Table 1. Response to Observations

Table 2. Response to independent Arborist's Report

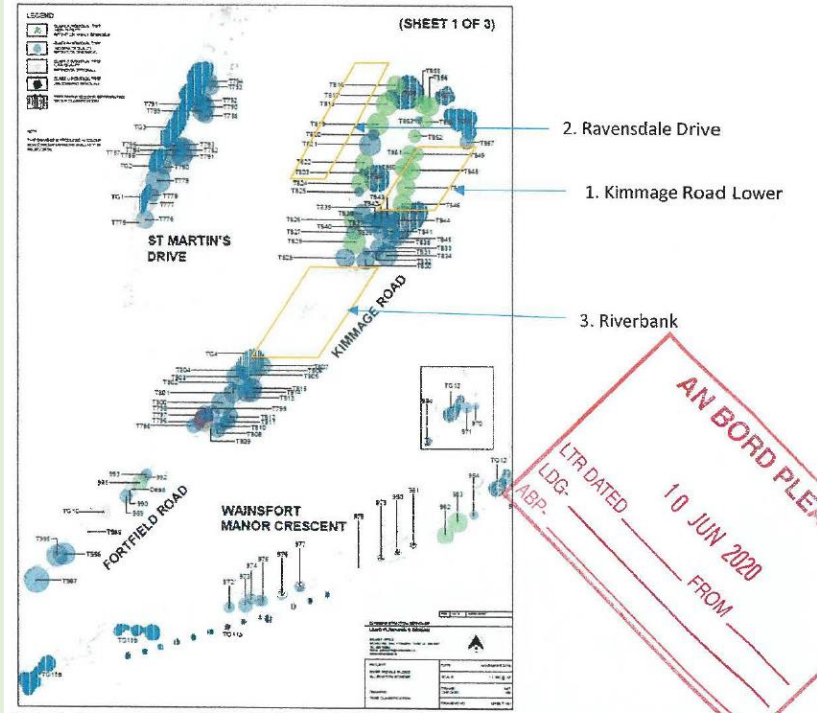
Name	Observation no.	Observation/Issue	Response
		<p>4. Having completed the work, the archaeologist should submit a written report to the Planning Authority and to this Department.</p> <p>5. Where archaeological material is shown to be present, avoidance, preservation in situ, preservation by record or (excavation) and/or monitoring may be required. The Department of Culture, Heritage and the Gaeltacht will advise the Planning Authority with regard to these matters.</p> <p>6. No site preparation or construction work should be carried out until after the archaeologist's report has been submitted and permission to proceed has been received in writing from the Department of Culture, Heritage and the Gaeltacht.</p> <p>The Wade and Metal Detection Survey shall be compiled as follows:</p> <p>1. The applicant is required to engage the services of a suitably qualified archaeologist to carry out Wade and Metal Detection survey in all areas where the Poddle riverbed shall be disturbed by the works. This should be licenced under the National Monuments Act 1930-2004.</p> <p>2. The metal detection survey should be carried out under licence granted under section 2 of the National Monuments Act 1987.</p> <p>3. Having completed the work, the archaeologist shall submit a written report to this Department for review.</p> <p>4. Where archaeological material/features are shown to be present, preservation in situ, avoidance, preservation by record (archaeological excavation) or archaeological monitoring may be required.</p> <p>The applicant shall be prepared to be advised by the Department of Culture, Heritage and the Gaeltacht in this regard.</p> <p>It should be borne in mind, that if significant archaeological remains are found, further archaeological mitigation might be required. Reason: To ensure the continued preservation (either in situ or by record) of places, caves, sites, features or other objects of archaeological interest.</p> <p>Having examined the documentation submitted in support of the present application, the NPWS of this Department very much welcomes the approach which has been adopted by the applicants in evaluating and mitigating the impacts of the proposed River Poddle Flood Alleviation Scheme on the flora and fauna occurring along the sections of the Poddle which will be affected by it, as well as avoiding any impacts on the Natura 2000 Sites present downstream in Dublin Bay. Given the constraints involved in constructing a flood alleviation scheme on a largely urban water course, the applicants appear to have incorporated measures in the proposed scheme in as far as was feasible to preserve the existing flora and fauna occurring on the Poddle. To compensate for some inevitable loss of trees and semi-natural vegetation, much tree planting is proposed as well as measures to allow the re-establishment of species rich meadow areas. The habitat enhancement measures proposed are also very worthwhile, including the construction of nesting platforms and artificial sand banks to encourage nesting by sand martins and kingfishers on Tymon Lake.</p> <p>This Department considers that such provision of refuges and breeding places for bird species should in addition be extended to otters. Though, as reported in the Environmental Impact Assessment Report, otter surveys in 2018 and 2019 found no evidence of the presence of otters on the Poddle, as also stated in this document there have been occasional reports of otter sightings in Tymon Park in recent years, particularly</p>

Name	Observation no.	Observation/Issue	Response
		<p>circa 2016. In the future improved water quality on the Poddle may lead to the re-establishment of sufficient fish stocks to allow a permanent presence again by otters on this stream. To facilitate otter re-colonisation artificial otter halts should be provided on or near the ponds in Tymon Park on either side of the M50, and if possible, further downstream as well. Such halts would provide resting and breeding places for these animals secure from human or canine interference. Similar holts installed elsewhere in Dublin have been readily occupied by otters, for instance by the Aviva Stadium on the Dodder.</p> <p>Considerable numbers of trees and shrubs are to be removed to facilitate the flood alleviation works. These are likely to harbour nesting birds during the bird breeding season.</p> <p>In the light of the above the Department of Culture, Heritage and the Gaeltacht recommends the following conditions should be attached to any permission granted by An Bord for the proposed flood alleviation scheme:</p> <p>1. That artificial otter halts are to be provided on or near the ponds in the two parts of Tymon Park on either side of the M50, the design of these holts to be agreed with the South Dublin County Dublin Heritage Officer and the National Parks and Wildlife Service; halts also be installed downstream in the vicinity of Whitehall Park and/or Poddle Park depending on space and design constraints. Reason: To conserve the otter, a species afforded a regime of special protection under the Habitats Directive (92/43/EEC).</p> <p>2. That any clearance of vegetation from the banks of the Poddle or adjacent areas as part of this scheme should only take place outside the main bird nesting season i.e. in the period from September to February inclusive. Reason: To avoid the destruction of nests, eggs, and nestlings of protected bird species.</p>

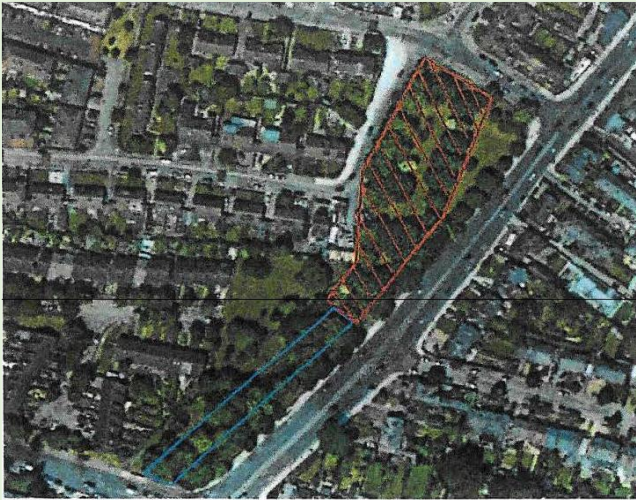
24.3	<p>Section 4.7.4 of the EIAR indicates that two options were proposed for this area, Option 1 was a 0.5 m high retaining wall stepped back from the river along the footpath which would greatly reduce the number of trees needing to be felled, and Option 2 was a 1.1m high wall along the river bank which would result in extensive tree removal and impacts on the river riparian zone (river bank). The EIAR reports that the residents of St. Martin's Drive rejected Option 1 in favour of Option 2, due to fears in regard to anti-social behaviour, as outlined in section 4.7.4 of the EIAR: "local residents expressed a concern about anti-social behaviour at this location and did not wish to see any improvements to the green area to change its use from a passive space to an active space. " An Taisce would question the transparency of this decision, and would query what percentage of</p>	A response to this has been provided in RFI no. 6.

Name	Observation no.	Observation/Issue	Response
		<p>the local inhabitants requested this. While we acknowledge that local concerns are very relevant, we are equally aware that there are a significant number of local inhabitants who are strongly opposed to this tree removal proposal, and the proposed option does not reflect their concerns. The tree removal will impact on a far greater number of inhabitants than those living directly adjacent to the proposed area of tree removal, as evidenced by the establishment of the 'Save the Poddle Wildlife Sanctuary' community group. Given the combined biodiversity and climate emergency declared by the Irish Government in May 2019, it would appear to us that the opinion of the directly adjacent residents should not be the absolute decider of a plan. Their views must obviously be accounted for, but not exclusive of other concerns, such as those of natural heritage, particularly when the risk of anti-social behaviour is hypothetical, and not firmly established. The River Poddle is a public space, providing an amenity for a broad range of people and biodiversity, and any planning decisions for the river must be cognisant of the needs of the wider public, not just a limited sub-set. In addition, we would question if the design of the 0.5 m high flood wall along the footpath (Option 1, rejected by local residents) could be adjusted to assuage those concerns, with the use of a transparent or a removable barrier, or another similar measure, the like of which are frequently employed in flood relief schemes along river banks in urban areas in order to protect the visual amenity of an area while providing flood relief. The consideration of alternative designs is a requirement under the EIA Directive Annex IV(2)): "A description of the reasonable alternatives (for example in terms of project design, technology, location, size and scale) studied by the developer, which are relevant to the proposed project and its specific characteristics, and an indication of the main reasons for this choice selecting the chosen option, taking into account including a comparison of the environmental effects" An Taisce would question if alternative designs for the flood wall for Option 1 at St. Martin's Drive have been thoroughly considered, with a view to protecting the established trees and riparian zone while preventing the development of a potentially anti-social space. While we welcome the proposal to replace any felled trees, mature trees have far higher biodiversity and carbon sequestration value than new trees, and should be given high level protection, where possible. The first option would also prevent the permanent alteration of the riparian zone of the river, and would allow for a limited amount of intermittent flooding which would somewhat mimic the natural floodplain system, in as much as that is possible within such an urban catchment, while providing protection for the established biodiversity. We would welcome a more in-depth analysis of the design options in this particularly sensitive area, and would suggest that the outright rejection of the first option due to the concerns of an unenumerated number of local residents should be revisited to endeavour to find a solution suitable for simultaneously protecting biodiversity and assuaging local concerns.</p>
